Engineering - PUD Plan Checklist

20170022 2018-03-26 Dev Plan Pre App Dwgs.pdf

23. B. General Information

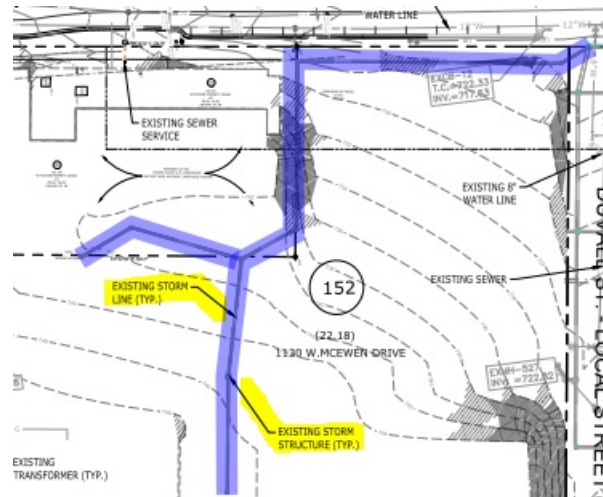
lance.fittro@franklintrn.gov The previous comment, "Applicant shall include Phasing schedule, including expected commencement date by phase, anticipated rate of development, and estimated date of completion by phase. Development milestones such as dwelling units, nonresidential building square footage, or significant off-site improvements are appropriate substitutions for dates. Clarify on the Development Plan the previously discussed phasing of the parking for Block A." has not been appropriately addressed.

Applicant shall identify the development milestones which will dictate the phasing of the parking for Block A and the construction of the proposed parking garage. "As dictated by market conditions" is not an acceptable development milestone for this purpose.
